“City of Havelock

Rebuilding Culvert Bridge at Sermon’s Park”

Addendum 1

June 2, 2021

FIGURE 2. ELEVATION, PLAN, SECTION

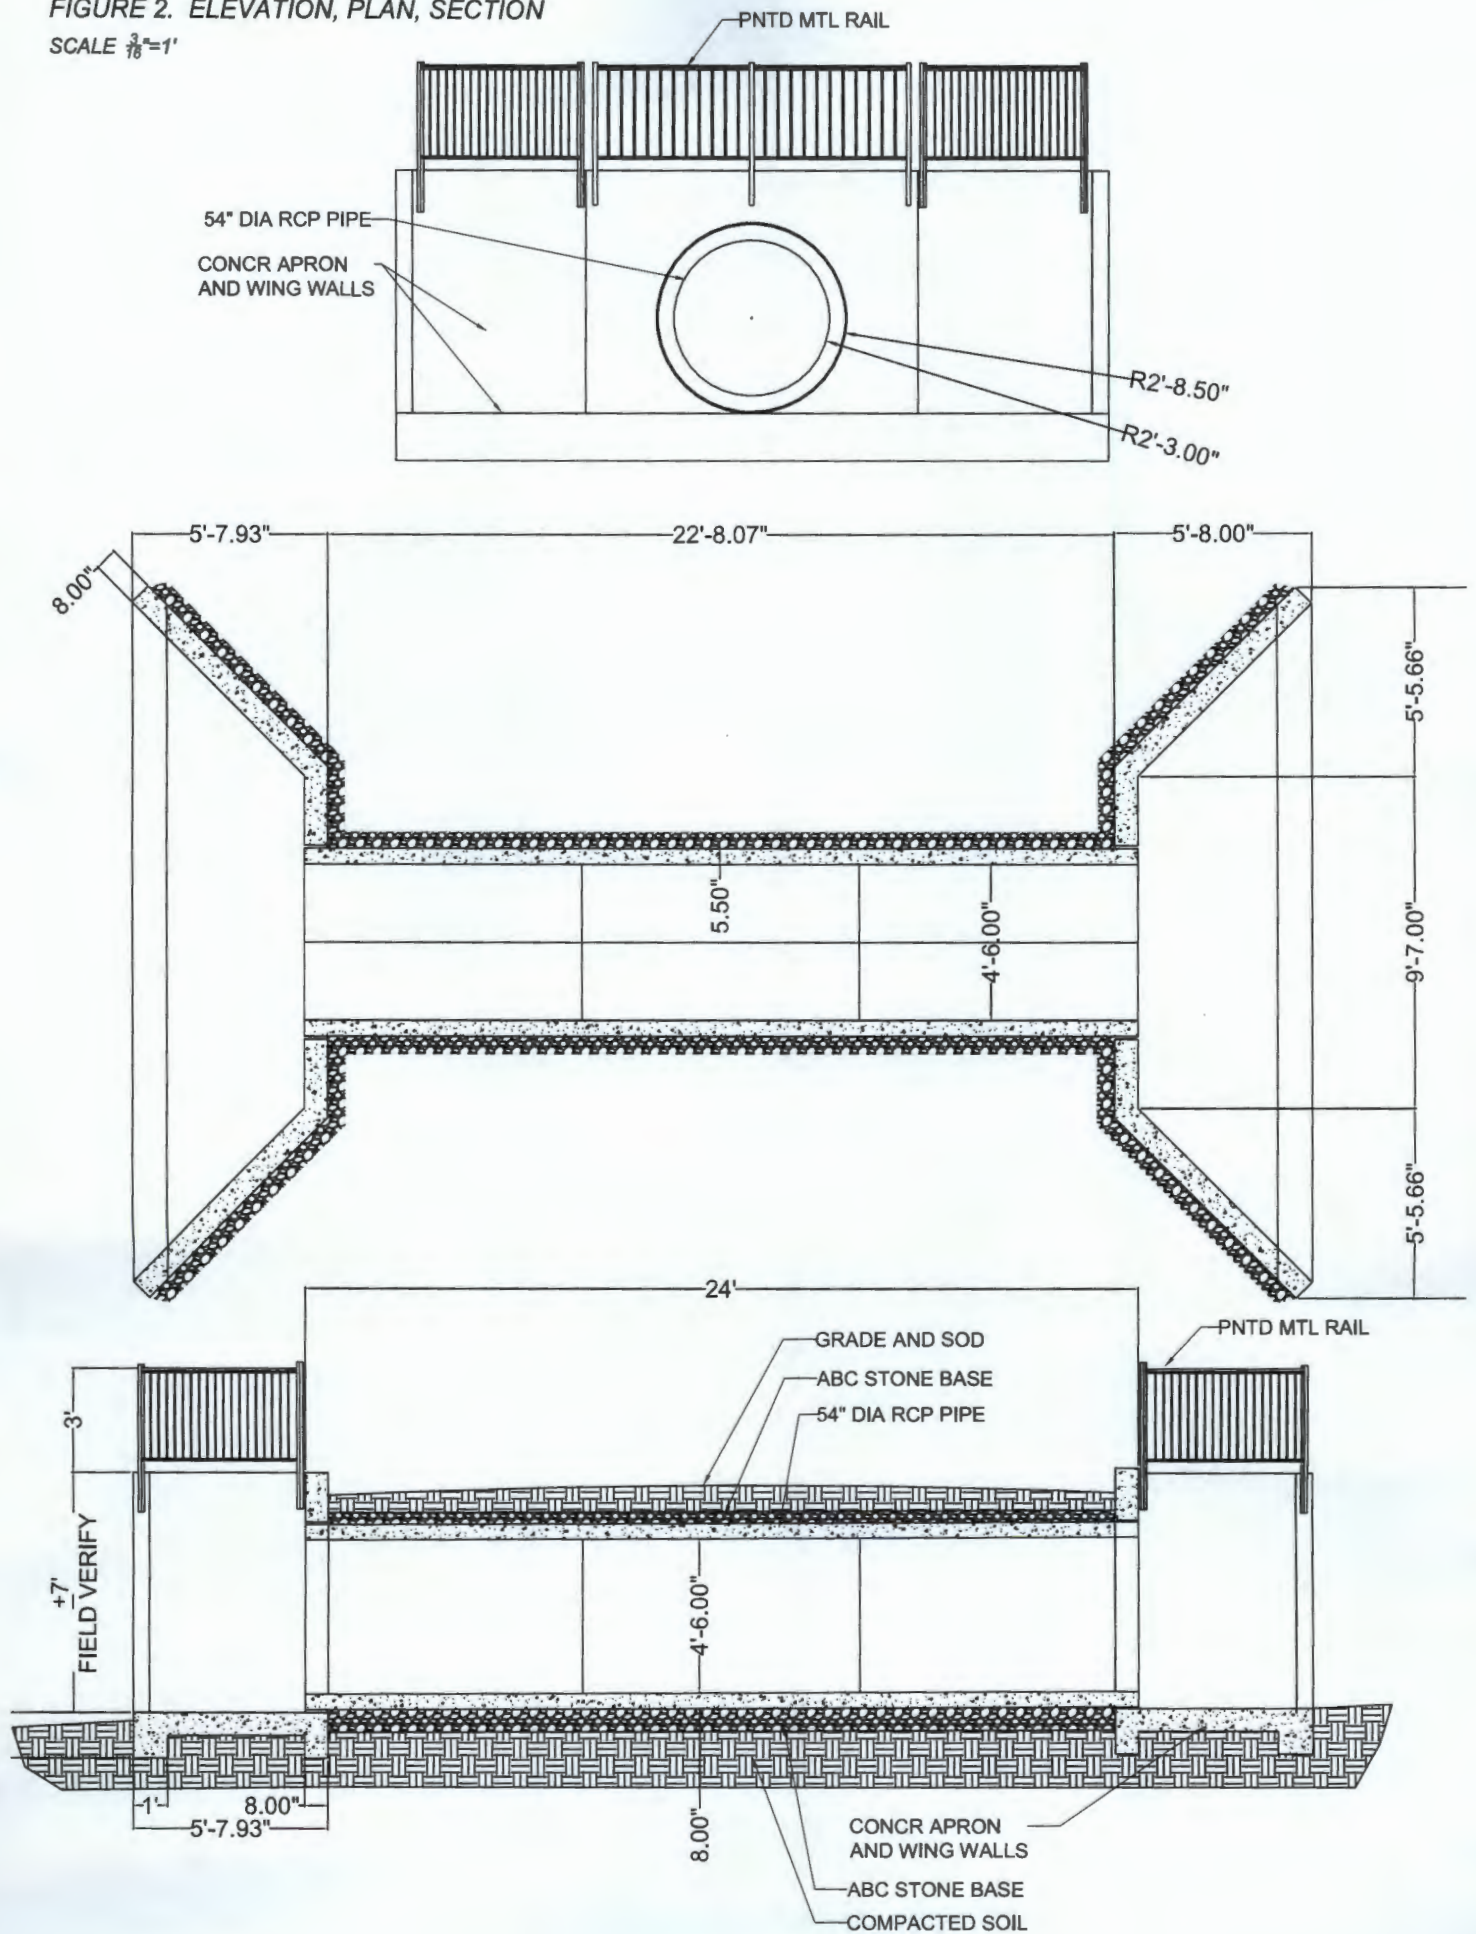
1. Since the 54” concrete pipes are made in 8 foot sections, is it ok to use three sections and make the overall length 24 ft. instead of 20 ft.?

2. Because of the steep grade of the sides of the ditch, can the wingwalls be straight and level with the headwalls, including railing?

3. Does the City want to replace the existing asphalt with new paving?

Yes. The overall length can be 24 ft. Refer to Scope Section “Material” and note that THREE sections of 8’ x 54” concrete pipe to be used instead of one. Figure 2, drawing 3 dimension to be 24 ft., not 20’.

Yes. Scope Figure 2 drawings: disregard sloped wingwalls and rails; Keep tops of wingwalls and rails even with top of headwalls.

No. since the existing asphalt is in such disrepair and overgrown, and that there is no other paving in proximity, please follow the scope Sections “Backfill and Compaction” and “Erosion and Sediment Control and Surface Restoration and Figure 2 drawing 3 to provide gravel, fill and sod.
